9/6/2024 3:59:45 PM \\LAG03DCWF00008.net\ods.state.tn.us\3SHARED\Traffic Operations Division\Traffic\DESIGN\Standard Drawings\Signalis (S)\N IN PROGRESS\TS015_091024.dgn

**4 LANES HYBRID BEACON
MID-BLOCK CROSSING**

**5 LANES HYBRID BEACON
MID-BLOCK CROSSING**

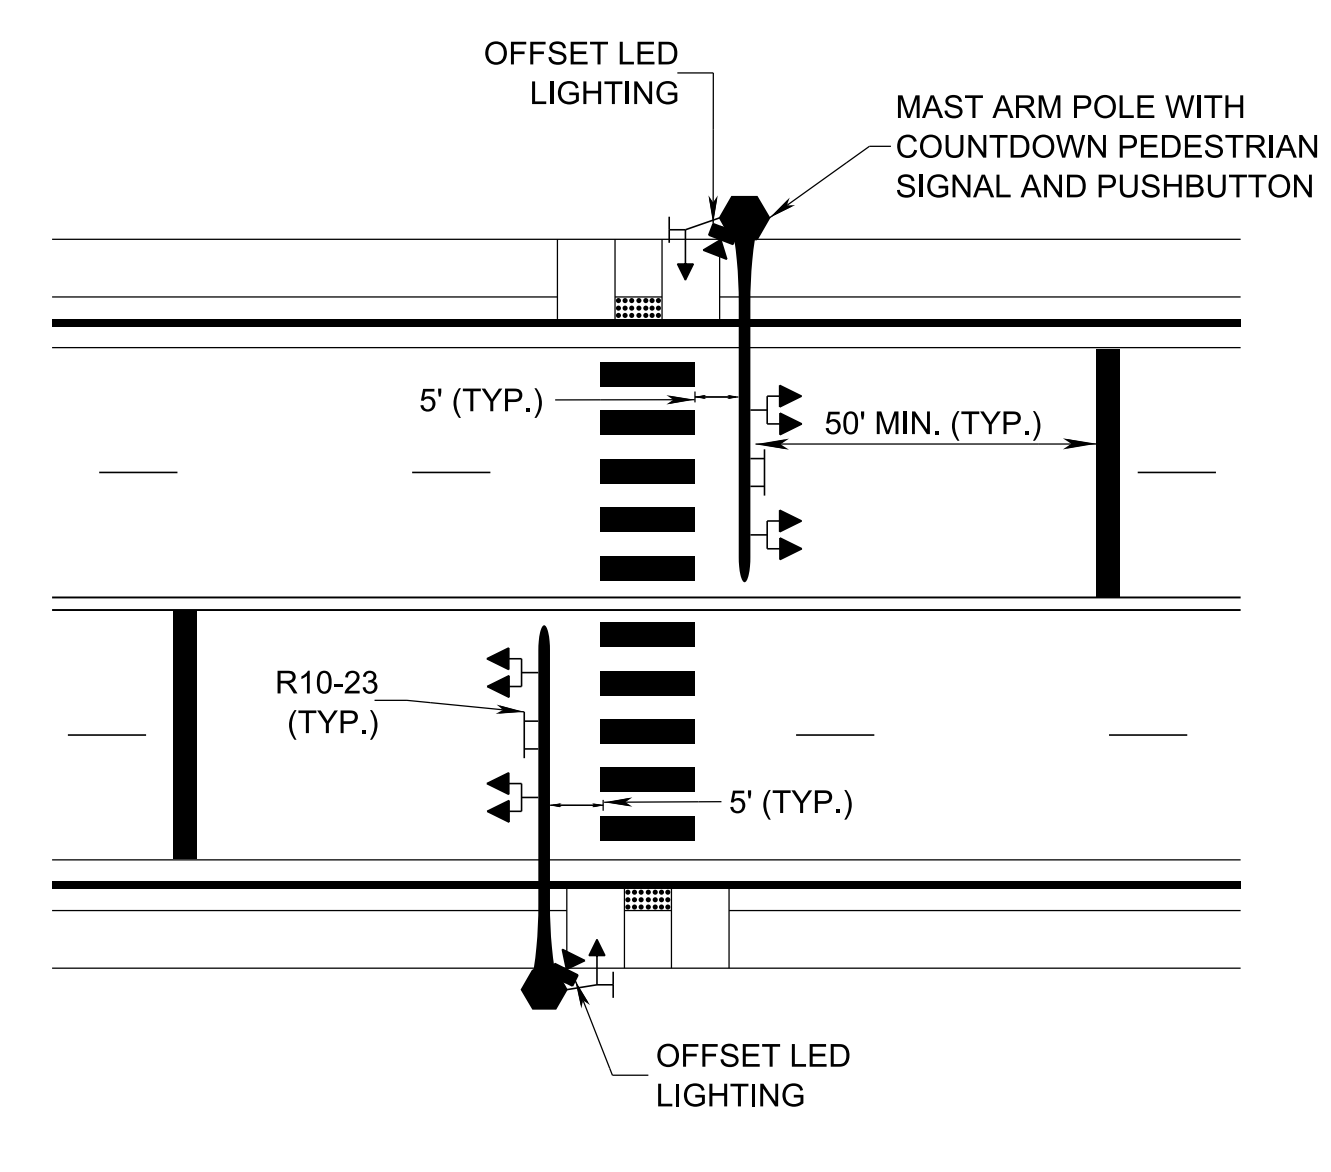
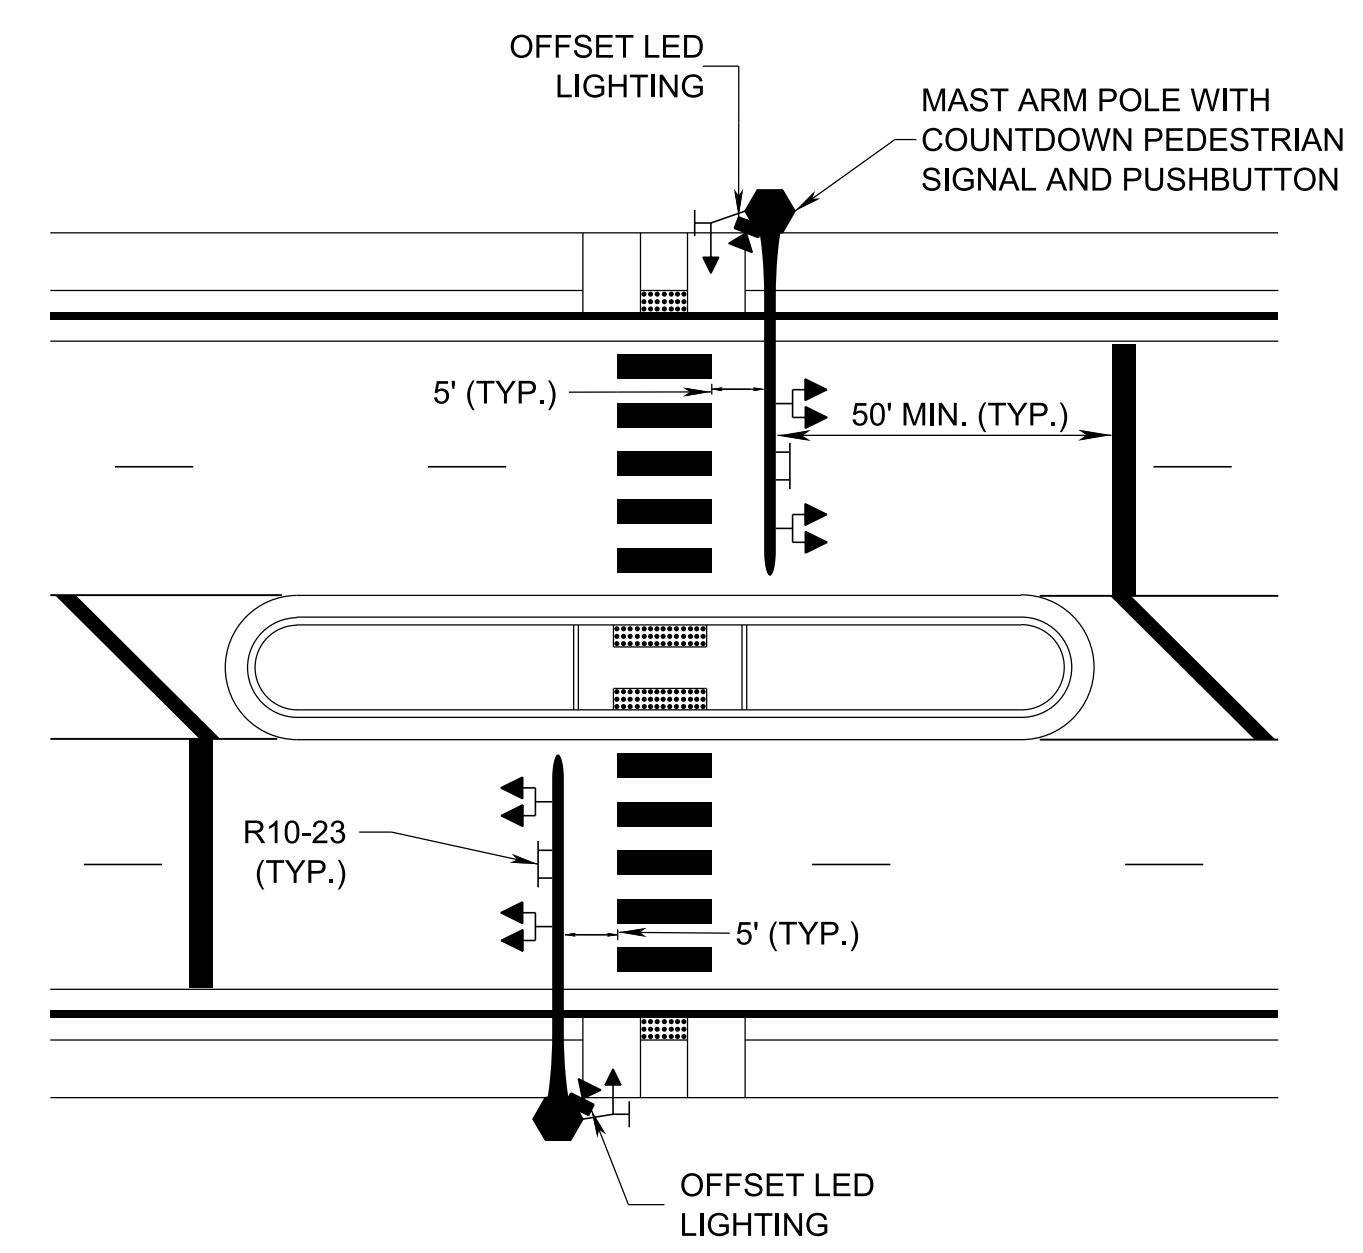
REV. 9-10-24: UPDATED FOOTNOTES "GENERAL NOTES". REVISED LUMINAIRE LABEL AND DIMENSION.

5. THE OFFSET LED LIGHTING LUMINAIRE SHALL BE MOUNTED AT 30 FEET.
 6. PEDESTRIAN PUSHBUTTONS SHALL BE INSTALLED IN COMPLIANCE WITH SECTION 4E.08. THROUGH 4E.13 OF THE MUTCD.
